Meeting: 1/19/2022
Project: 129 S. Gay Street Window replacement
Applicant: Kristy Wu

Level I Minor Alteration of an Existing Building/Structure

1-A-22-DT

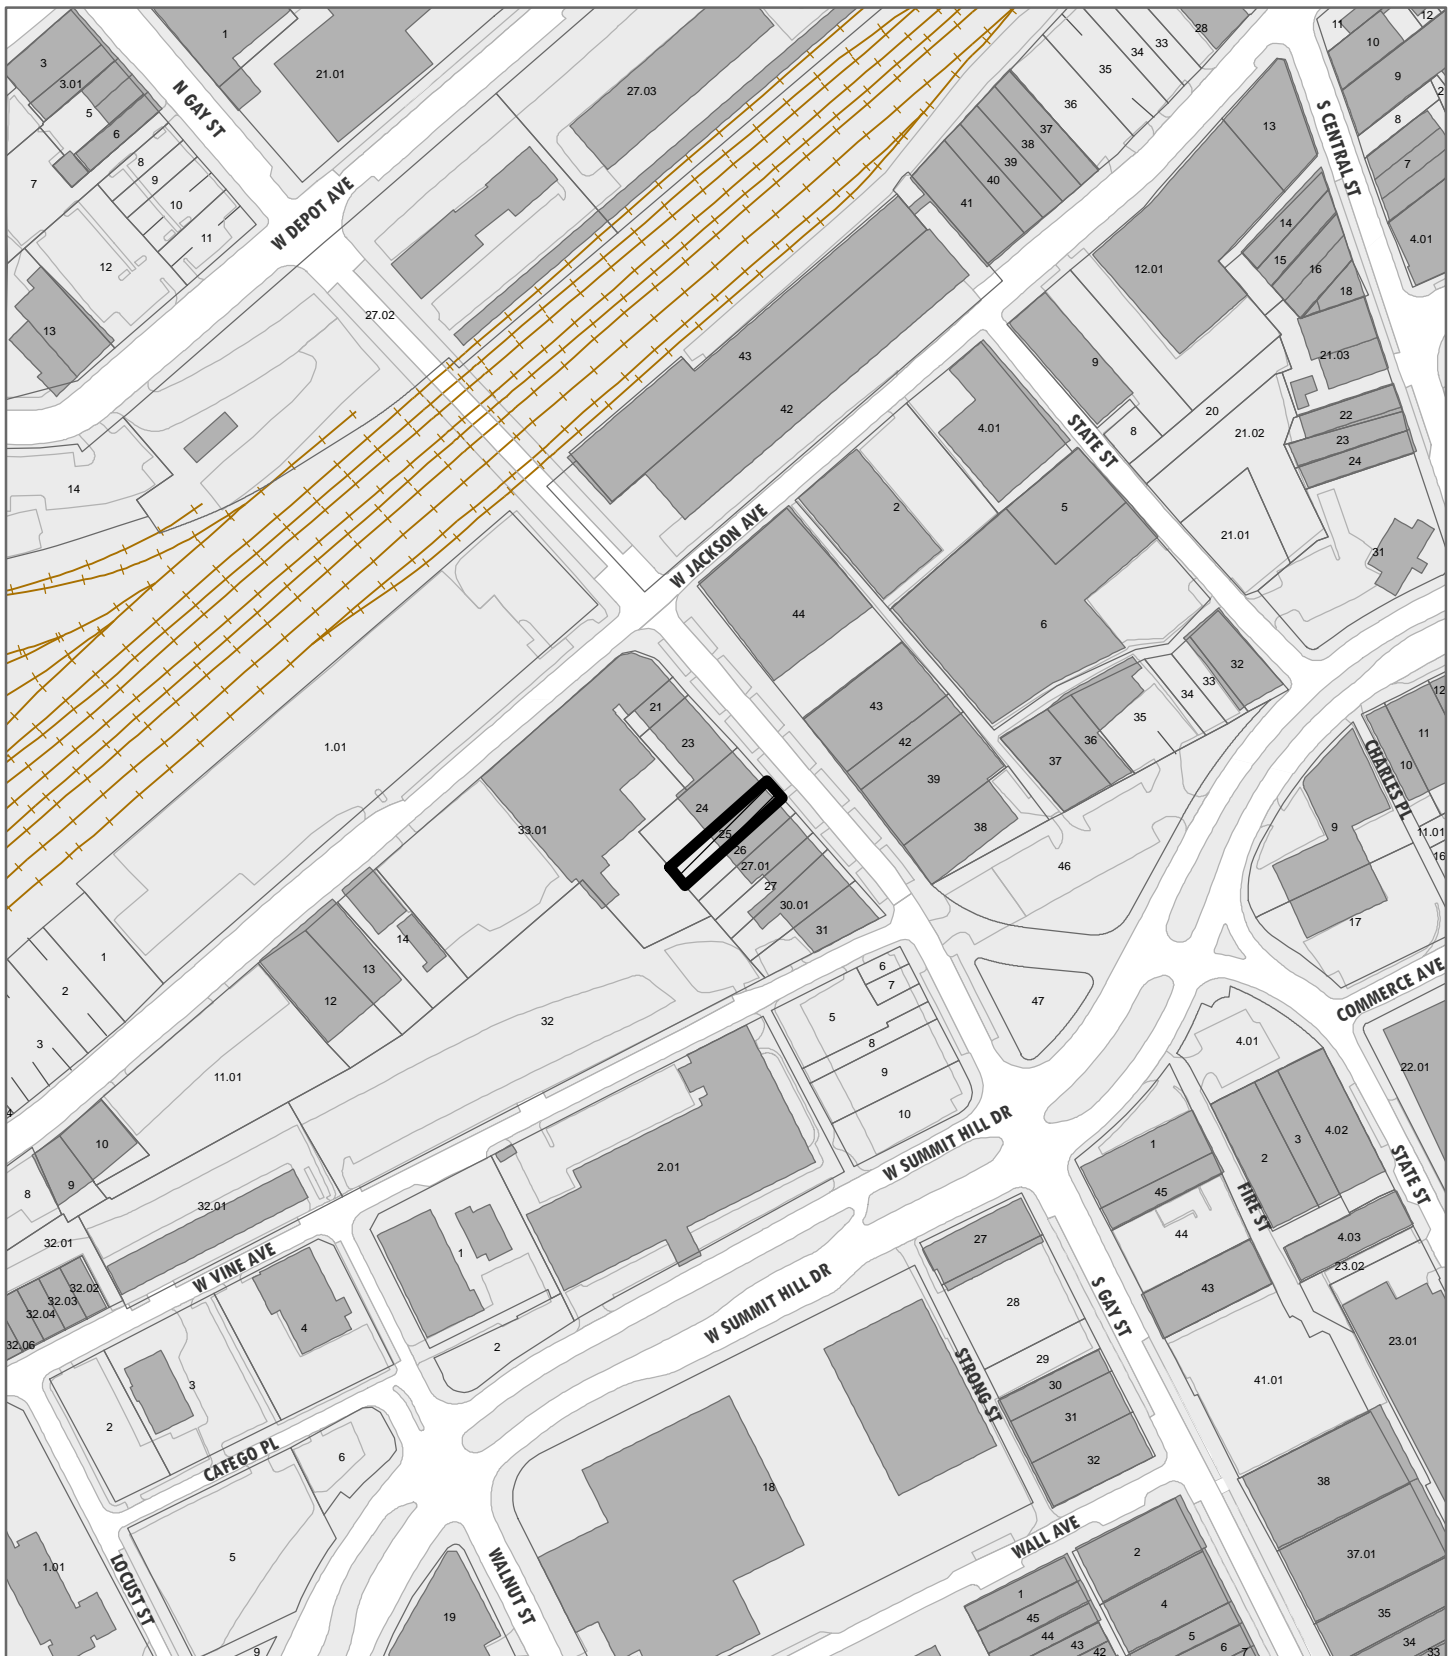
Proposed replacement of four windows on third story of façade. Existing windows are non-historic, one-over-one, double-hung wood. Proposed replacement windows are one-over-one, double-hung, aluminum-clad wood.

Proposed windows will be same overall size and design as existing. Scope of work does not involve modification to multi-light transom windows above center bays.

129 S. Gay Street is a contributing resource to the Southern Terminal and Warehouse Historic District, so the Historic Resources section of the design guidelines applies. The existing windows are not the original windows. As the guidelines recommend replacing windows duplicating "material" of original or historic materials, the proposed window replacement cannot be approved on a staff level. Overall, the proposed window replacements are custom designed to replicate overall size, glass size, and muntin arrangement of the existing one-over-one, double-hung wood windows. Aluminum-clad wood can successfully replicate the muntin profile and size of wood sash; as long as the replacement windows are painted to match the rest of the building, replacements will match the existing and be consistent with the existing second-story windows. Aluminum-clad wood windows have been previously approved as new windows on historic buildings (121 E. Jackson Ave) and replacement windows on historic buildings (301 State Street, 7-C-16-DT).

Staff recommends approval of Certificate 1-A-22-DT as submitted.
